PLANNING BOARD AGENDA

**DECEMBER 13, 2021
REGULAR MEETING ~ VIRTUAL**

Re: Completeness/Technical Review (Tolomanasi) No. 3
1707 Oak Terrace
Block 11, Lot 12
H2M Project No. LKCP 2004

**Re: Completeness/Technical Review (Use Variance)
Ternowchek, 1819 Parkway
Block 17, Lot 9
H2M Project No. LKCP 2107**

DRAWING TITLE
ELEVATIONS - LOT A

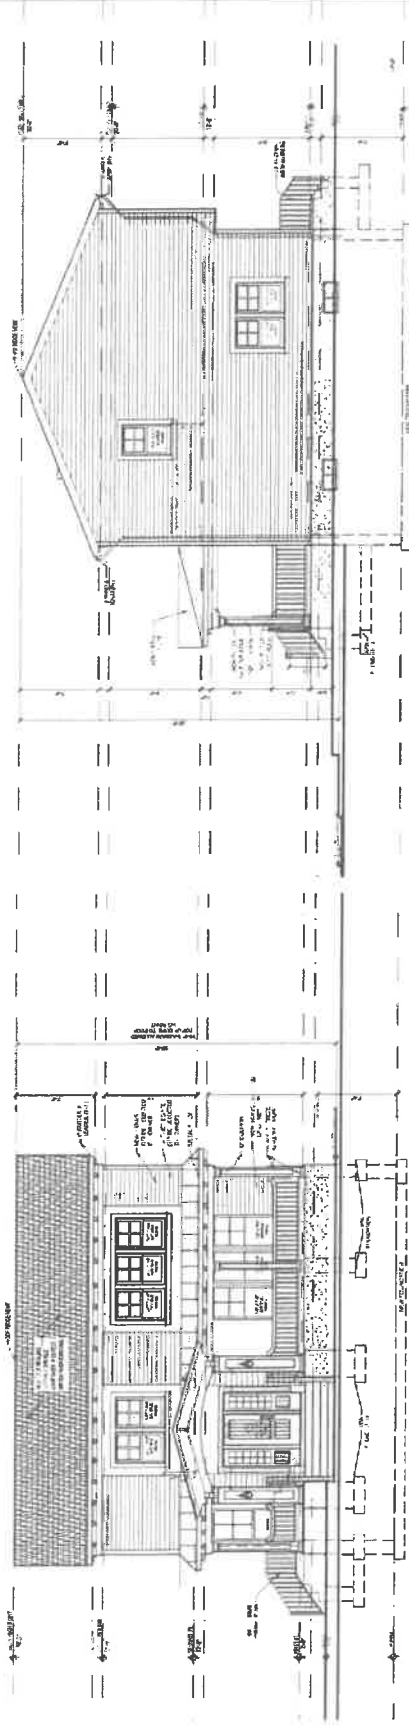
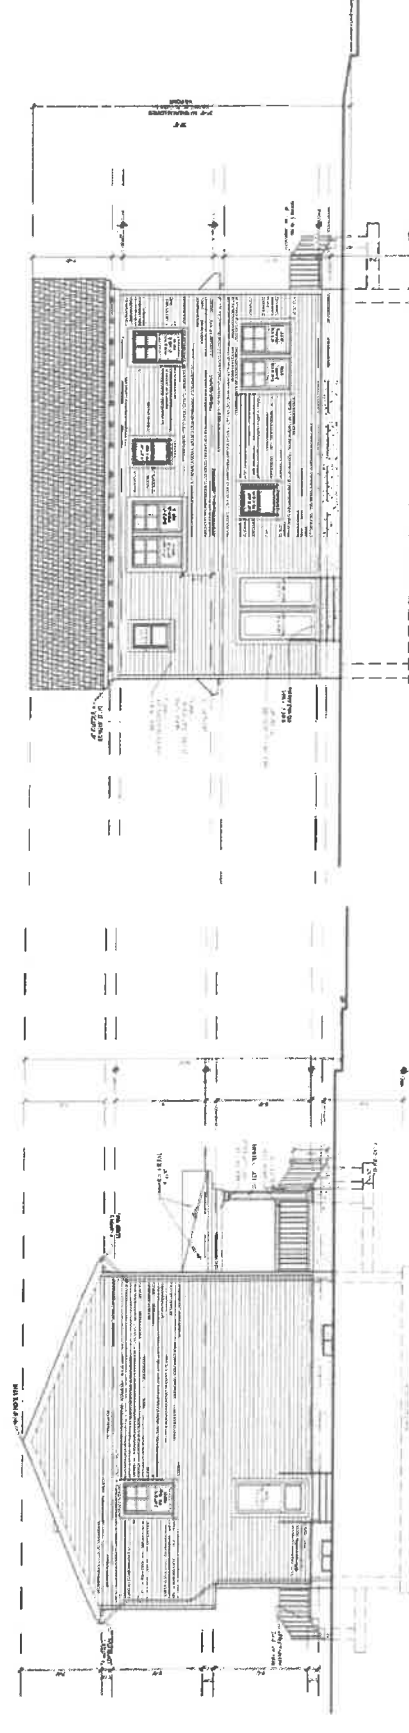
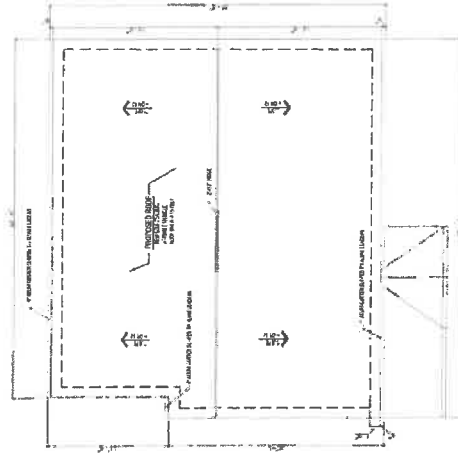
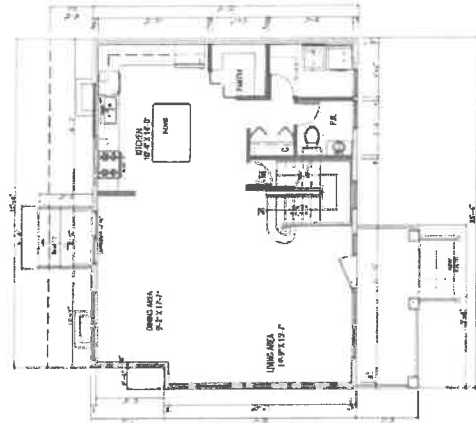
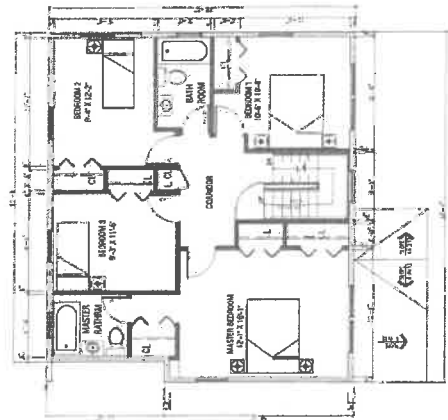
In addition, the architectural plans depict elevation views that do not scale to the dimensions noted on the plans. Specifically, the Building Heights for both structures are denoted as 35 feet in height as defined by the ordinance; however, the structure for Lot A only scales around 32 feet in height and the structure for Lot B only scales around 31 feet in height. The Board should elicit testimony regarding this issue as I believe the plans do not accurately depict the proposed structures, and the variances for Building Coverage have as much to do with building bulk as it does building footprint. **This issue is more clearly defined now on the new plans; however, I recommend that the Board specifically approve a height for each structure within the resolution as the plans still make references to 35 feet in height.**

1. Relocated and reduced the parking spaces square footage. The parking spaces provided are 32'-0" from the intersection of 17th Avenue and Oak Terrace and the square footage reduced from 540 square feet to 380 square feet.
2. The relocation of the parking spaces allows for the front yard coverage to increase to 56%
3. The parking area will be pavers reducing the total impervious coverage to 47%.
4. Building height has been indicated on drawings and will be less than the maximum height allowed of 35' from top of curb to roof high point.
